R. S. PEARCE

PINS Reference: 20010156

WRITTEN REPRESENTATION - HORNSEA PROJECT THREE OFFSHORE WIND FARM

**Hornsea Project Three
 Grid Connection and Indicative Route Options**

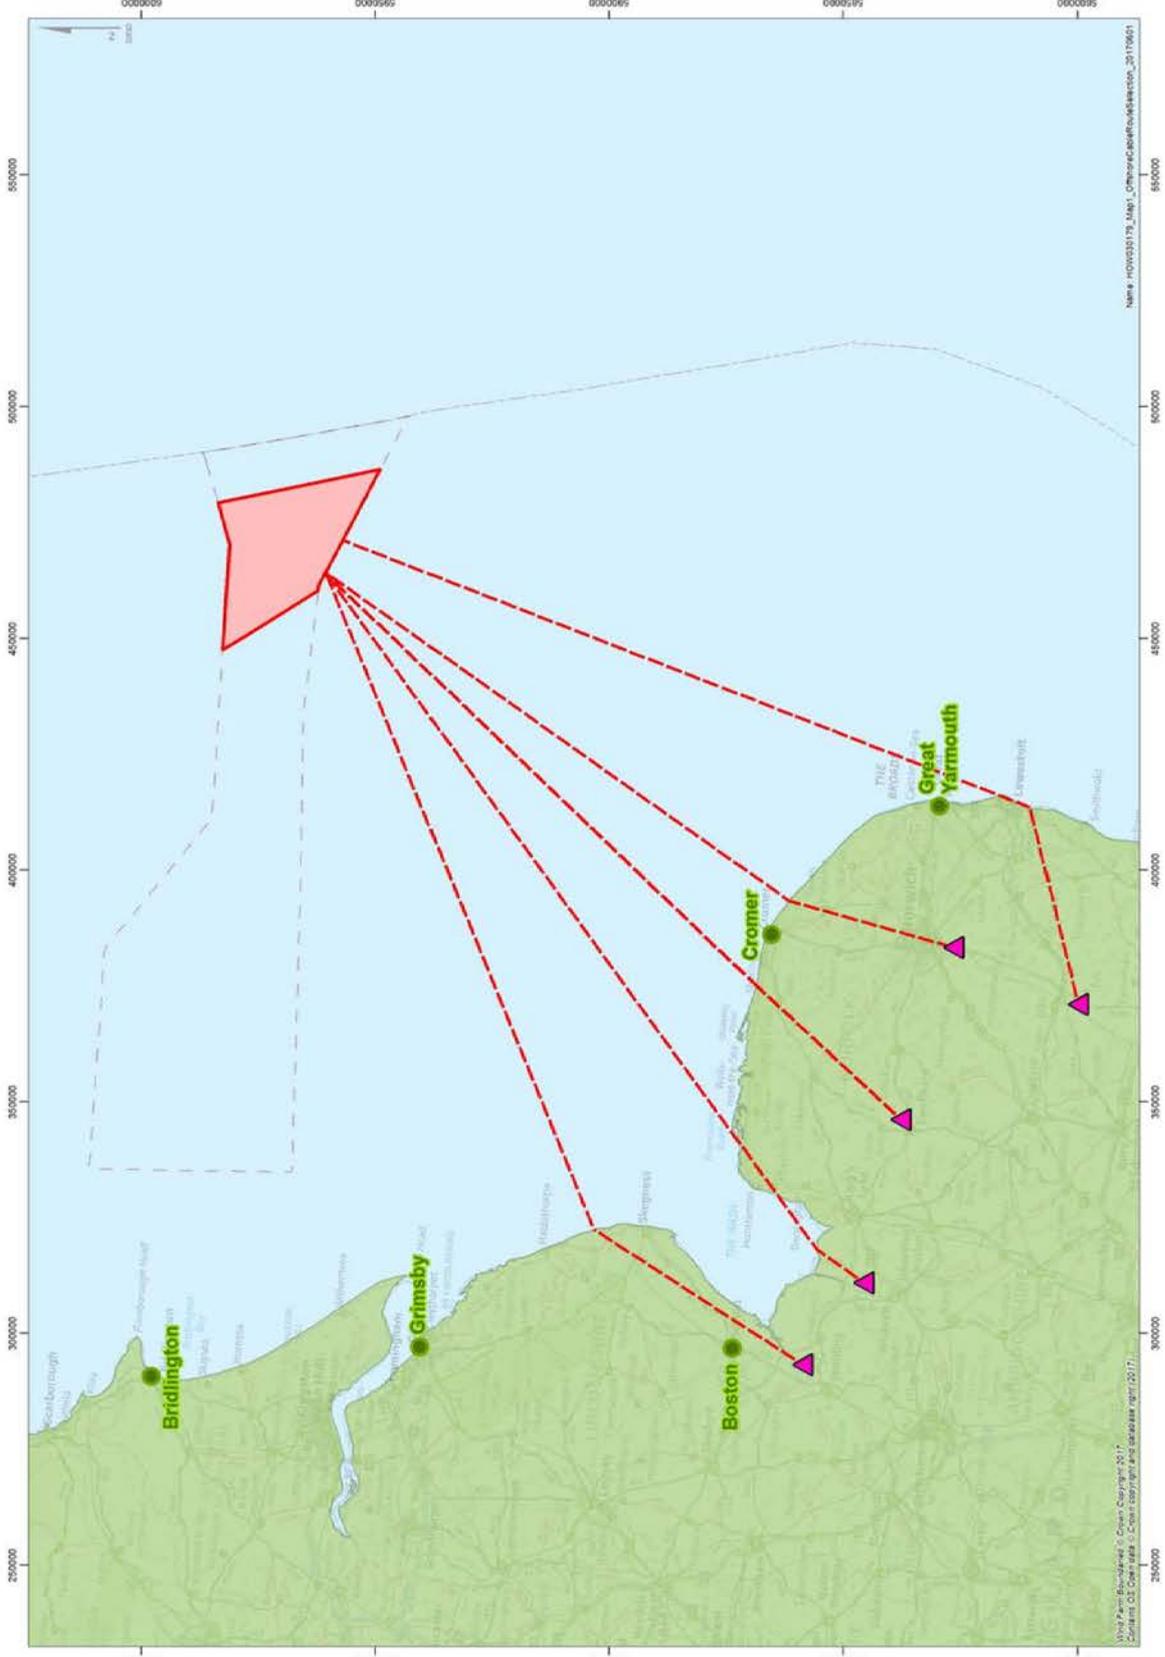
The Hornsea Three Project explored five options: Norwich Main, Walpole, Newton, Bicker Fen and Eye (See attached). Accepting that Necton had been previously offered to Vattenfall, why was Walpole so easily discounted? Dong's Race Bank Project is routed through the Wash to Walpole and sets a precedence for any environmental impact. There is nothing in either the PEIR, or the details provided by yourself, that would discount Walpole as not being more cost effective than Norwich Main. The cable length would be approximately the same when considering the need to route an on-shore cable around Norwich from landfall at Weybourne, and, would be primarily a Marine Cable with approximately a 6 mile on-shore requirement. We contest that the cost of excavating 55km's of land, with a 60m trench, 1.5m deep, as in the current plan, will be significantly more expensive than routing the cables through the Wash to connect at Walpole. We

For the Hornsea Three project, a range of options were jointly considered with DONG Energy, including Walpole amongst others as you point out. Connecting at Walpole would involve a longer cable connection and consenting challenges for DONG Energy, that they are best placed to expand on. A new substation would also be needed somewhere in the vicinity of the existing Walpole substation. We wouldn't be able to simply extend the existing Walpole substation because that would give rise to system issues. Norwich Main was identified as the preferred connection option by DONG Energy and National Grid as it presented the shortest overall cable route and the lowest environmental risk.

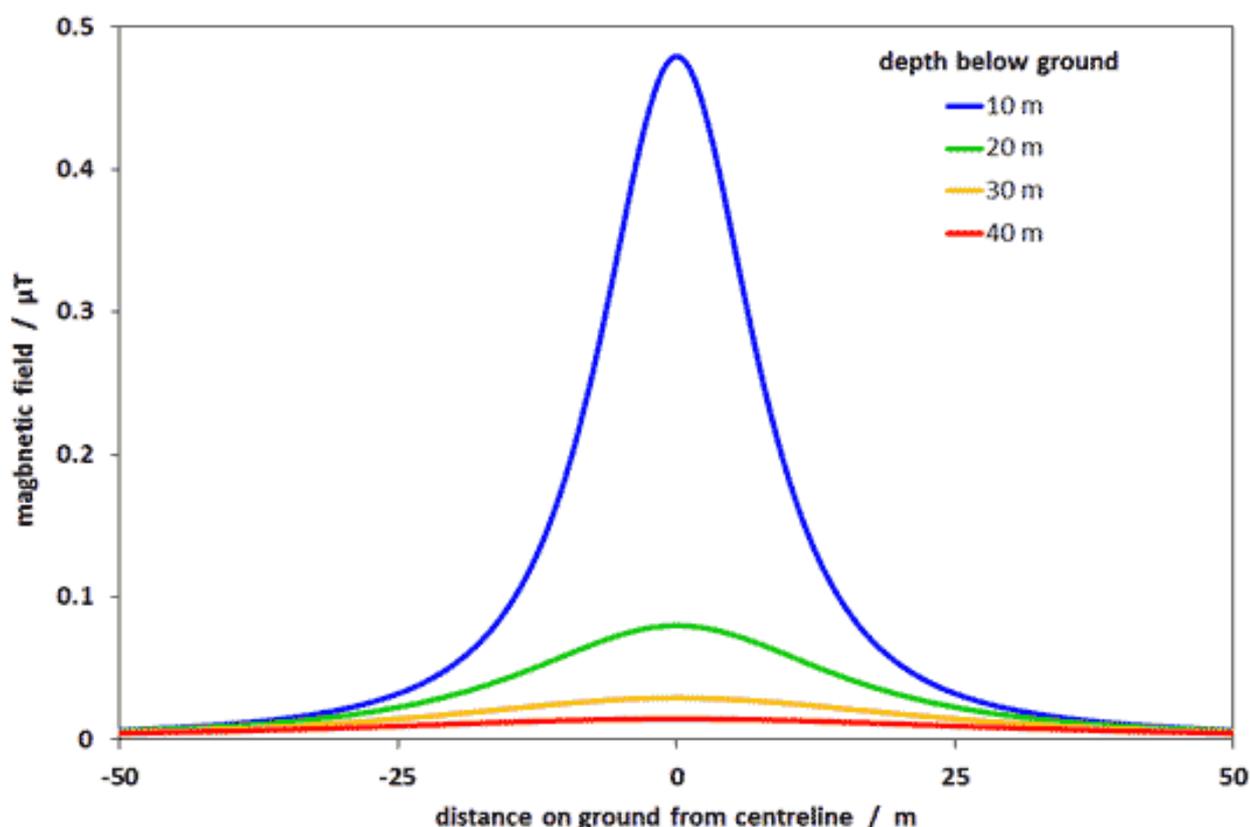
Your FAQs only graphically show that the EMF from an underground cable dissipates with distance, and, most importantly to anybody else reading this reply, you have removed the values from the x and y axis. Presumably you would agree with the following graph (for a 500A circuit) provided by the NRPB (7)? What is the amperage of your cables? For multiple cables, what is the cumulative EMF?

Clearly, without the scale the information you have provided in your FAQ graph is almost meaningless.
